GW - 294

**GENERAL
CORRESPONDENCE**

Re: Response to October 10, 2008, e-mail from Mr. Griswold regarding Remedial Workplan
97-04 Townsend Site, Plains Marketing, L.P.
Lea County, New Mexico

Figure 2
 Site Map and Proposed Well Locations Map
 Plains Marketing, L.P.
 TNM 97-04
 Lea County, NM

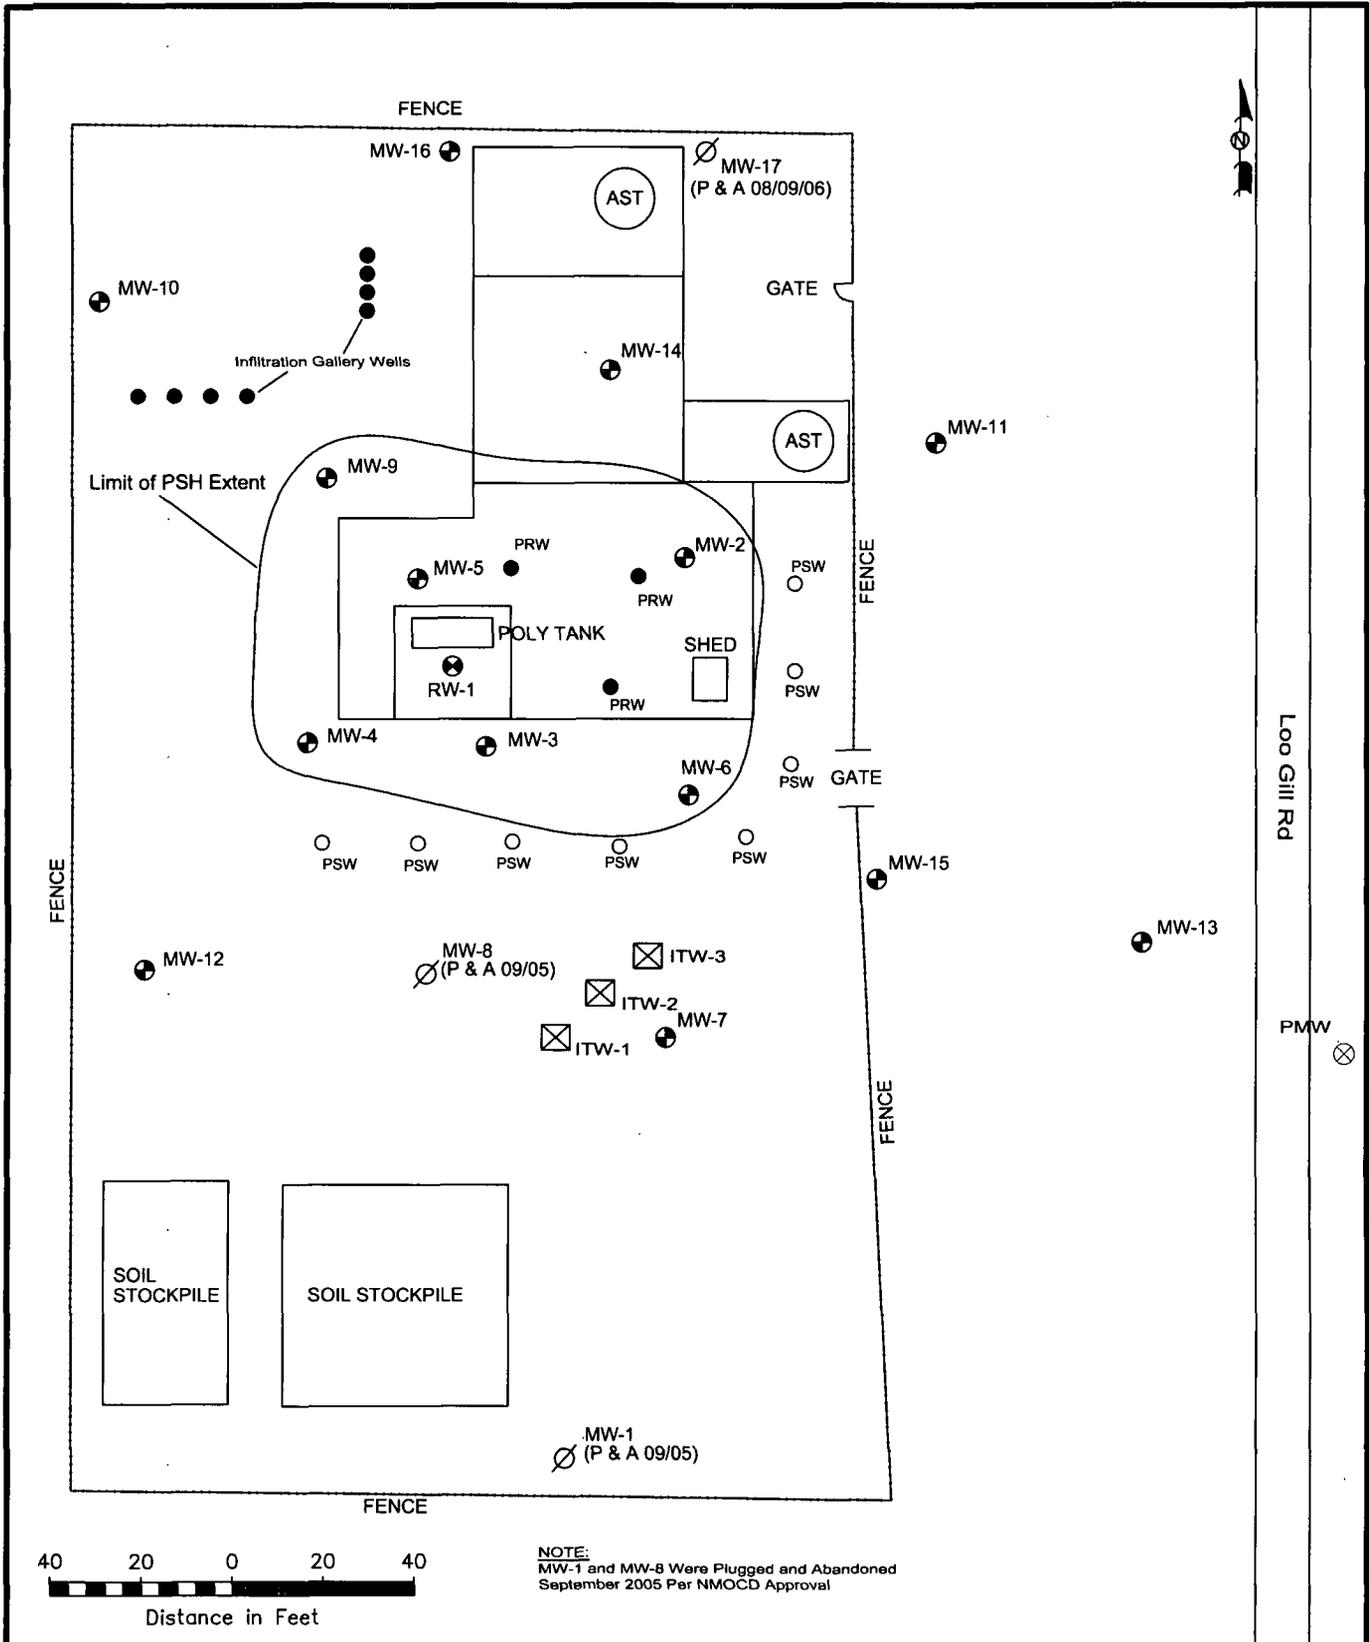
The workplan indicates 3 new total fluids recovery wells are to be installed and along with RW-1 will come online using pneumatic pumps. The anticipated pumping rate will average two gallons per minute per pump. This equates to a daily discharge of 11,520 gallons. My concern is the higher the flowrate, the lesser percentage of NAPL per unit volume of recovered groundwater, the higher the cost of carbon treatment, and the greater induced potentiometric gradient due to infiltration. The fractionation tanks should perhaps be sized based on the 2 gpm figure, but provisions should be made to throttle back the flows to as low as maybe 0.5 gpm/pump. A short-term (several hours) pump test on RW-1 could be readily undertaken using MWs-3, 4, and 5 to observe drawdown.

The workplan also states product skimming pumps will be used in MWs-2, 3, 4, 5, 6, and 9 in the bottom paragraph of page 1, but this is never discussed again. Based on our conversation, it is Plains intent to skim these wells until the apparent thickness of product is substantially reduced. Thereafter, they will be gauged to monitor the effect of the total fluids pumping system.

The total depth (TD) on the proposed sparging wells is 75 ft below ground surface (DTW of ~50 ft) with two feet of 20-slot screen at each well's bottom. The deepest well previously advanced at the site (RW-1) is only 67 ft bgs and I am concerned there might be lower-permeability lithology at greater depth which would pose problems for the distribution of injected air. Greater depth also requires increased pressure to achieve aeration, thus higher initial capital costs, higher operating costs, and more heat (i.e. loss) in the discharged air from the pump. Given the soil type and an approximate well spacing of 20 feet, it is appropriate (and cheaper) to have a TD of 65 ft for the sparging wells incorporating the same 2 feet of screen. These wells can be constructed using standard 20-foot sections of 2" diameter SCH 40 PVC bell end pipe with glued joints rather than threaded well casings. If the bores stay open in the saturated zone (which I doubt), then an artificial sand pack should be placed around the screened intervals, but a natural pack will be sufficient. However, placement of the annular seal above the screens is very important. Also, considerable care must be taken to ensure the depth of the screen below the

- Plains proposes to conduct a pump test on recovery well RW-1 and use monitor wells MW-3, MW-4 and MW-5 as observation wells to observe drawdown as suggested. Upon

- Plains proposes to utilize skimmer pumps in order to skim the maximum amount of product from monitor wells MW-2, MW-3, MW-4, MW-5, MW-6 and MW-9. Crude oil recovered from the six monitor wells will be piped to a 500 gallon holding tank to await collection by Plain's for re-injection into the pipeline system. Upon removal of free product to the maximum extent practicable, other methods of removal of the remaining contamination within the well will be contemplated. These options include but are not limited to over-pumping of the wells, use of oxygen socks, and/or absorbent socks to remove minor thicknesses of product. Wells will be gauged to monitor progress of product removal and the effectiveness of the remediation system until final closure of the site.

- Plains proposes to adjust the air sparging well completion depths to approximately 65 feet bgs, each constructed with 2-inch diameter pvc piping with bell ends and glued joints and two feet of screen. The well casing will be completed with the appropriate sized filter pack to allow for sufficient air transport. The filter pack will be placed approximately 2 feet above the top of the screen with the annular seal of bentonite placed above the filter media and properly hydrated. In addition, considerable care will be given to properly place each screen section at approximately the same depth. Each air sparging well will be properly developed following installation and prior to manifolding of the supply lines.

Infiltration Gallery Diagram
 Plains Pipeline, L.P.
 Townsend 97-04
 Lea County, NM

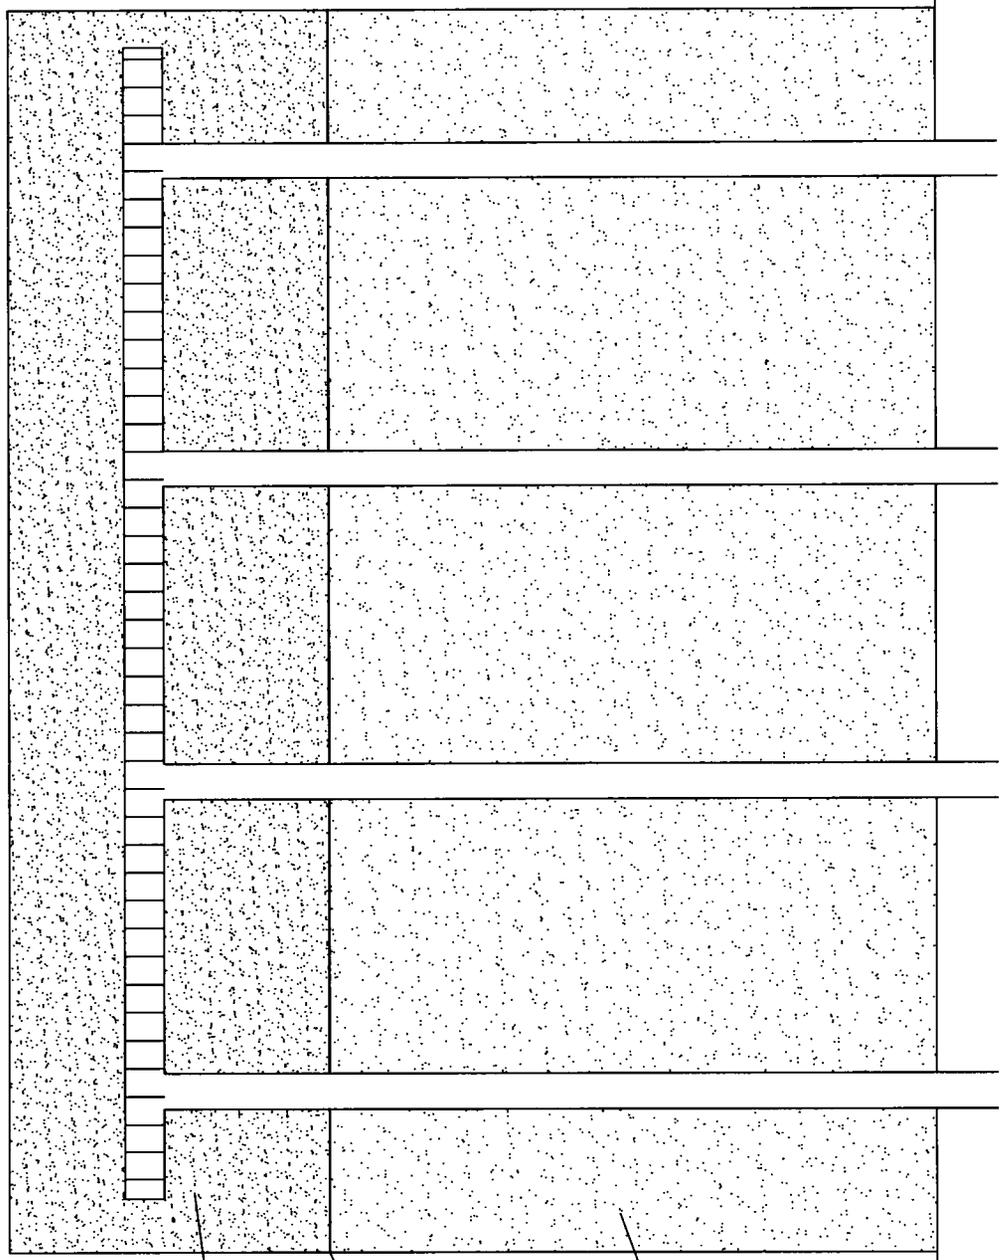
The present intent is to reuse the existing infiltration galleries to deal with treated groundwater. They were originally installed as part of a multiphase extraction system. Could you please provide me with a protocol for establishing the viability of these galleries and contingencies (other than off-site disposal) for rehabilitation or replacement in case they are compromised.

- Plains proposes to rehabilitate the existing infiltration gallery and opts to construct an additional infiltration trench next to the existing infiltration gallery to ensure adequate infiltration capacity. The trench infiltration gallery will be excavated to a depth of approximately 30 feet below ground surface (bgs) and will consist of PVC piping and backfilled with approximately 10 feet of crushed gravel filter media. A poly liner will be placed over the gravel pack and covered to the surface with clean soil. Please see the attached diagram of the rehabilitated infiltration gallery.

Enhanced Recovery System
 Layout Diagram
 Plains Pipeline, L.P.
 Townsend 87-04
 Lea County, NM

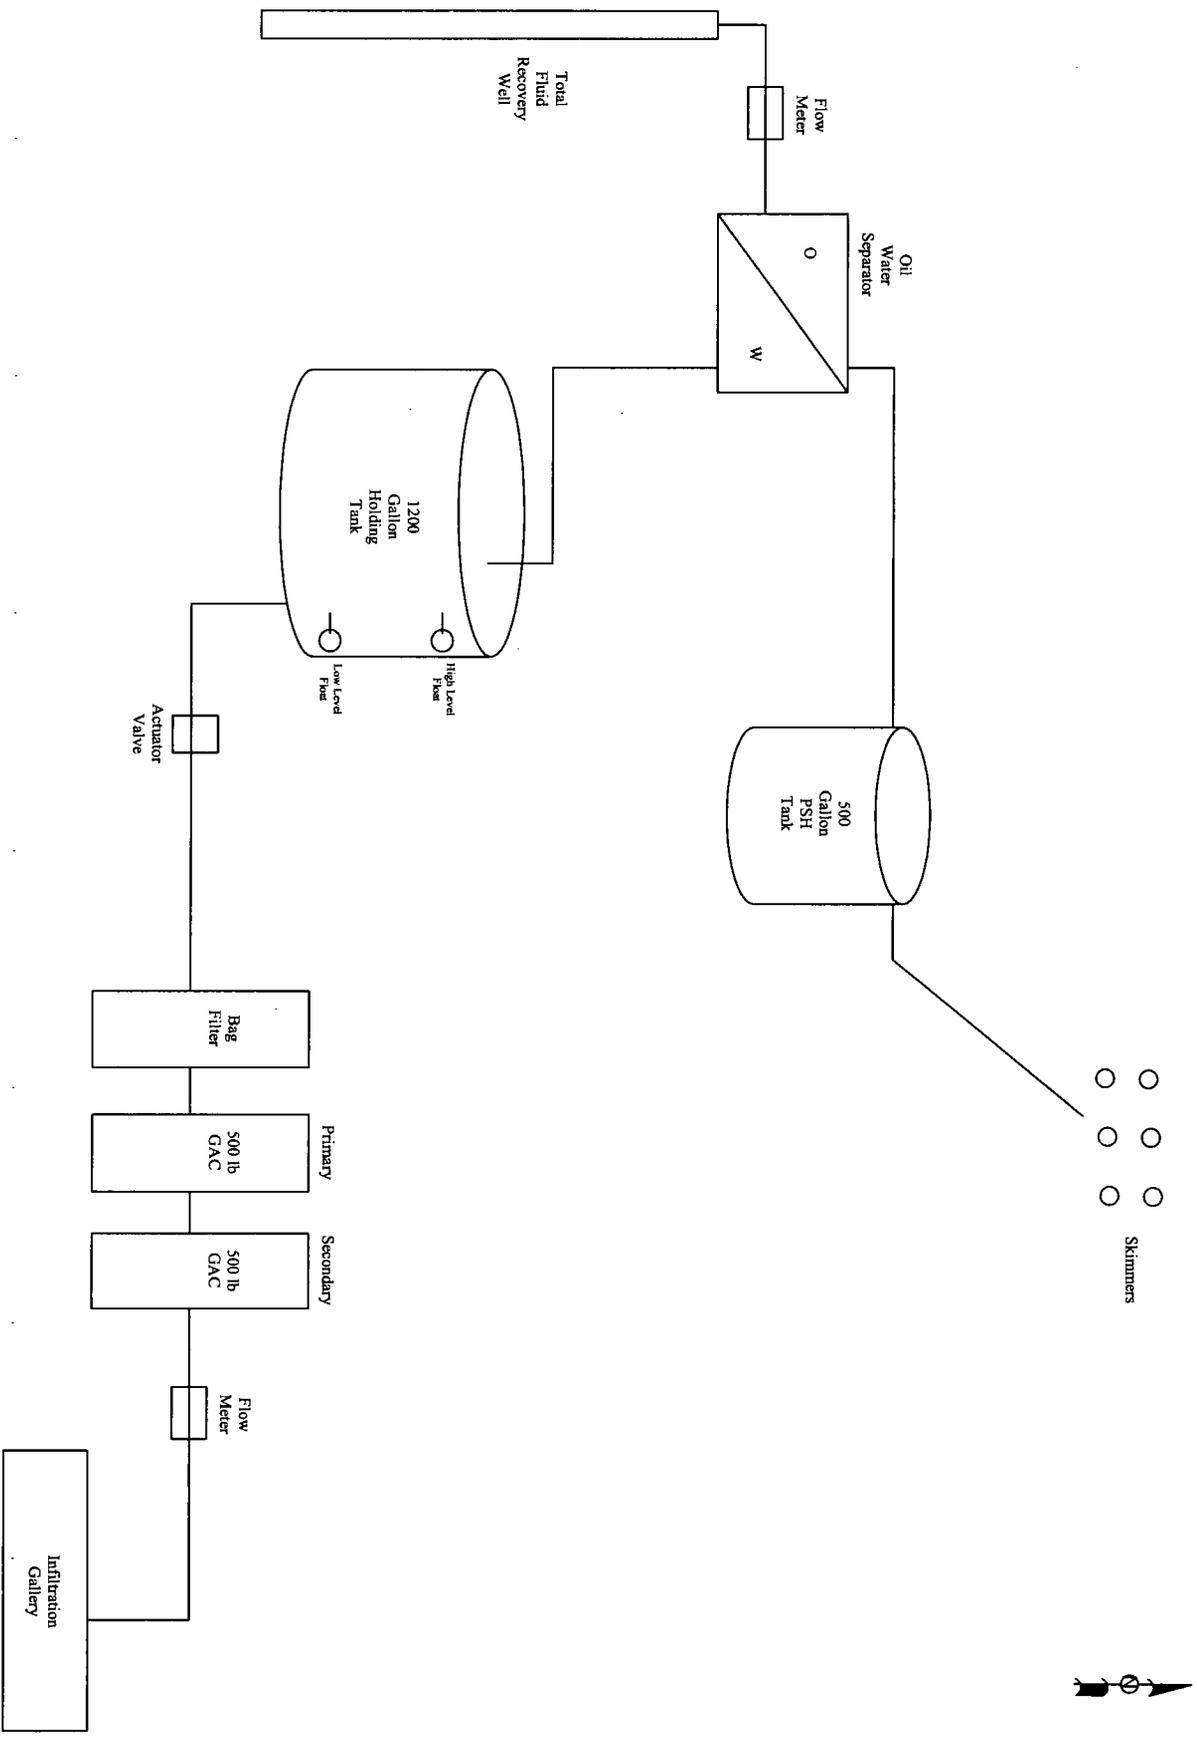
The workplan says you intend to use stinger/packer combinations in each sparging well operating at anywhere from 10 to 50 psi. Why not just manifold directly from the blower into the wellheads? Try not to run this at much more than a few psi above the pressure required to push out the water from the well casings and begin aeration. Otherwise you can dewater the zone completely and defeat the purpose. Excessively high flowrates can also cause a significant problem for fugitive vapor emissions at the surface, especially when there isn't any vapor extraction in the vadose zone. One psi is equivalent to 2.77 inches of water, so if the top of the screens are 13 feet beneath the water table, then it should require only 6 psi (plus piping loss and minimum formation entry pressure) to begin bubbling from the screens. I would estimate as a first stab to try and run the system at no more than 9 or 10 psi depending on the flowrate you can get, which is also a function of the pump and how fast you spin it. Anywhere from 5 to 10 cfm of air per well will be adequate, so the overall blower requirement would be between 40 and 80 cfm.

I would agree that a Roots-type blower (rotary-lobe compressor) would be appropriate, just don't buy a pump which doesn't have lubricant or it will die in a few months. Be sure to include an intake air filter, silencers on both intake and exhaust, a check valve, a bleed valve, and a pressure relief valve. I would recommend the blower be belt-driven such that you can change pulley ratios to get the blower speed you want. If 3-phase power is available it will save electricity if the motor is 2 hp or bigger. You need to be wary of heat at the outlet of the blower as this can cause piping failures even in CPVC especially if the pipe is exposed.

No volumes were provided for the proposed frac tanks or carbon filters which I need to know as part of the permit. There also must be impermeable secondary containment for tanks and filters capable of holding 130% of the volume. If liquids are released into the secondary containment, they cannot be allowed to remain for more than 72 hours.

- Plains proposes to manifold directly from the blower to the wellheads and maintain a pressure of approximately 5 to 10 psi in each well. A blower already secured by Plains will be utilized to produce an approximate maximum flow rate of 80 cfm. If necessary, excess blower capacity will be vented to control flow rates, pressure, and temperature produced at the blower.

- The blower will be a 3-phase blower utilizing all required filters, check valves, muffling systems and relief valves to prevent or control upset events. Heat buildup within the

- An oil-water separator tank will be installed as the first vessel that produced water will enter. This tank is capable of 20 gpm flow and will be used as a product separation tank that all free phase crude oil will be captured and isolated. A 1200 gallon holding tank will function as a backup separation tank to allow for the capture of any groundwater passing through the oil water separator. Fluid leaving the main holding tank will pass through a bag filter and then into the carbon filter system. A system of two 500 pound granulated activated carbon canisters (GAC) will be utilized, plumbed in series to ensure complete removal of organic compounds from the effluent stream prior to discharge into the infiltration gallery. Flow meters will be used prior to the oil water separator tank and after the last GAC filter. Product captured by the oil water separator will be piped to a separate 500 gallon tank for holding crude oil. Please see attached diagram for system layout. All tankage will be enclosed in sufficient secondary containment, and no released fluids will be allowed to remain in the containment for more than 72 hours.

Figure 2
 Proposed Monitor Well Locations
 Plains Marketing, L.P.
 TNM 97-04
 Lea County, NM

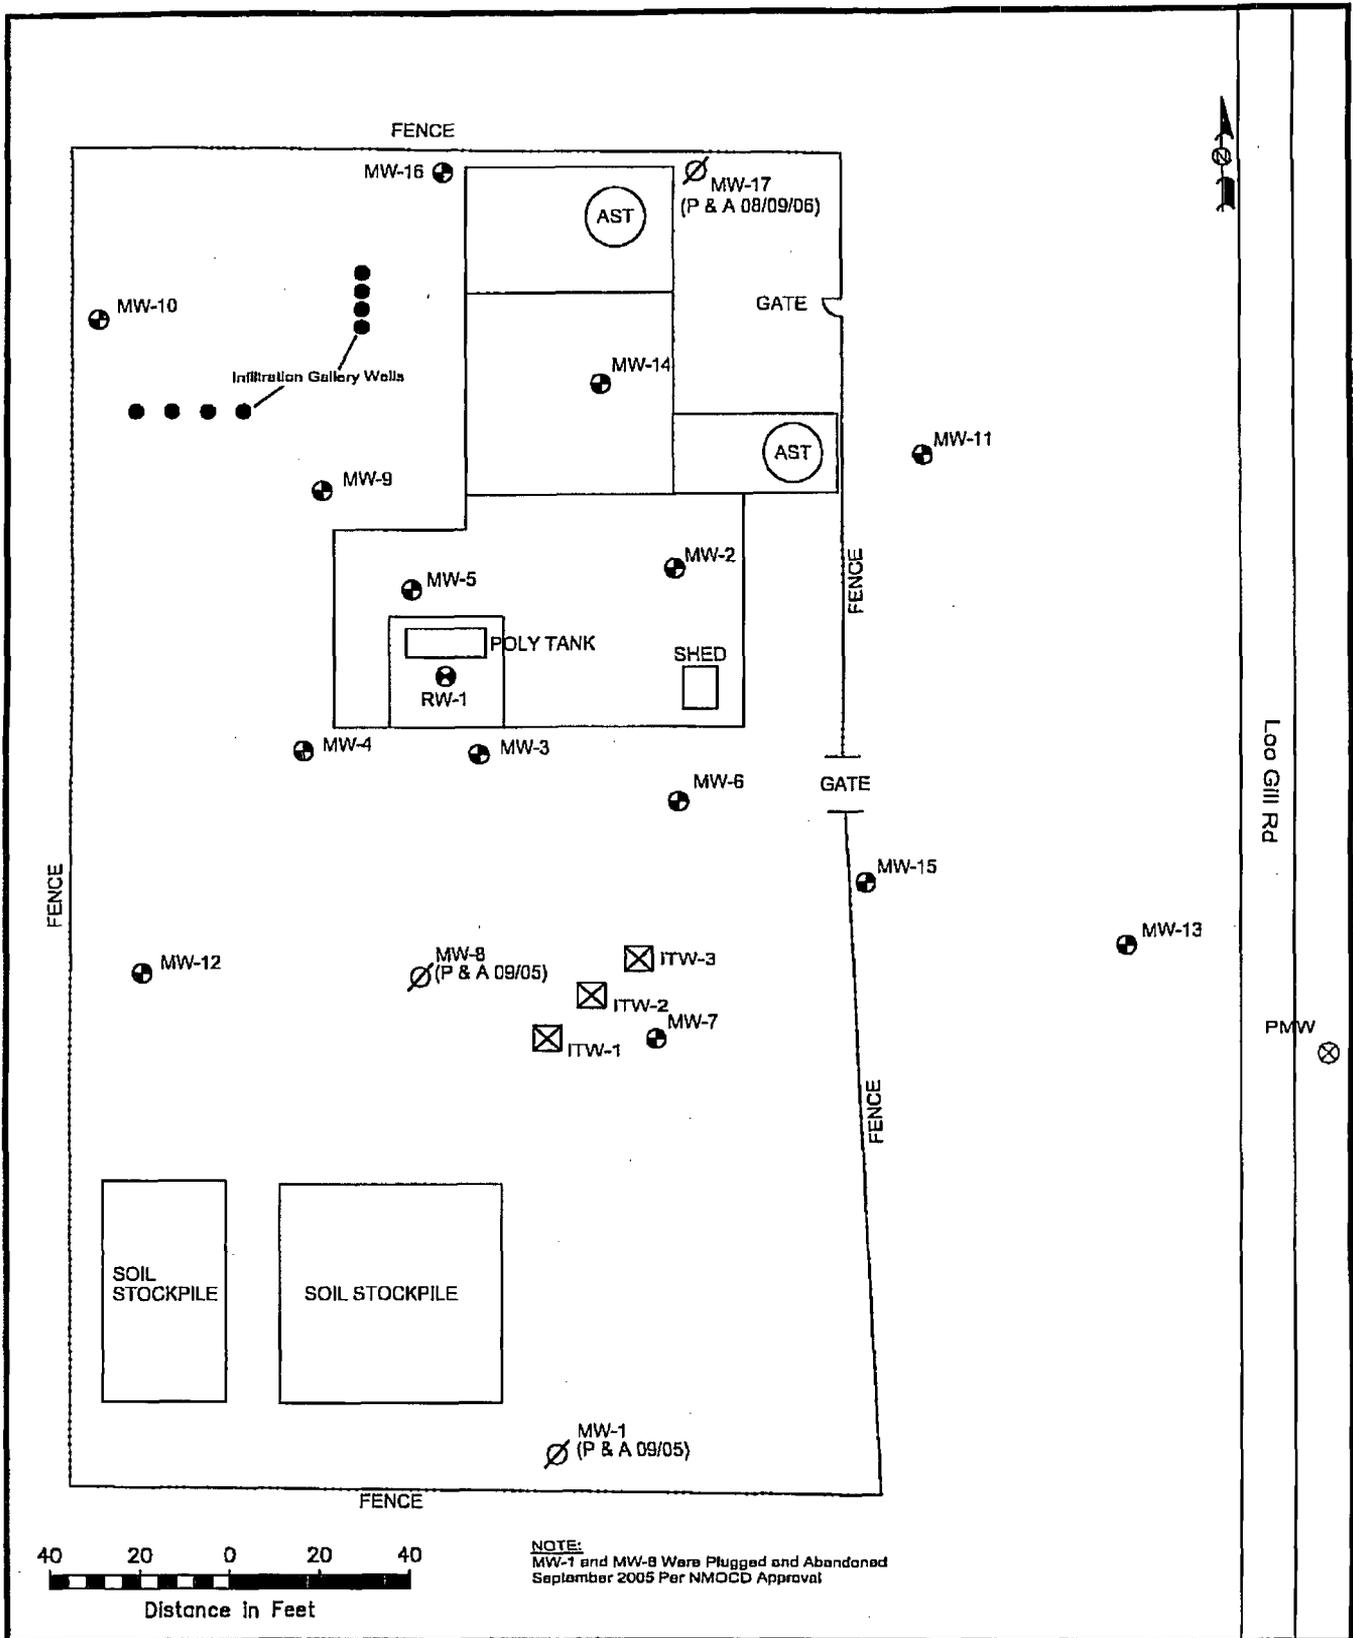
4. "Infiltration test wells ITW-1, -2, and -3 are not located on recent maps nor are the actual infiltration wells (farther north) used as part of the earlier dual-phase extraction system as required under Condition 5b of prior discharge plan approval (dated January 12, 2000). If any or all of these wells are of no further use, Plains should consider abandonment, but only after proper approval from the OCD."

9. "A new groundwater monitoring well is needed downgradient of existing well MW-13 to better define the dissolved-phase contaminant plume which is migrating toward the southeast."

Response: Plains requests formal approval from the NMOCD to properly plug and abandon the three Infiltration wells, identified as ITW-1, ITW-2 and ITW-3, located adjacent to monitor well MW-7. The three ITW wells are approximately 17 feet in depth

and will be properly plugged and abandoned according to NMOCD regulations by a drilling contractor licensed in the State of New Mexico (See the attached Site Map for well locations). At this time, Plains proposes that the eight infiltration gallery wells located between MW-9 and MW-10 be left in place.

Response: A new monitor well, identified as MW-18, is scheduled to be installed downgradient and to the southeast of existing well MW-13. The drilling will be scheduled upon written approval of the off-site property landowner. The new monitor well will be drilled to a total depth of approximately 65 feet below ground surface and constructed with 25 feet of slotted screen. Soil samples will be collected by utilizing a split barrel core sampler with soil samples being analyzed for Total Petroleum Hydrocarbons (TPH) by EPA Method 8015B and for BTEX by EPA Method 8021B. Upon drilling completion, the new monitor well will be properly developed by purging approximately 3 well volumes of groundwater. Groundwater samples will be collected by using a clean disposable bailer with samples analyzed for BTEX, EPA Method 8021B.
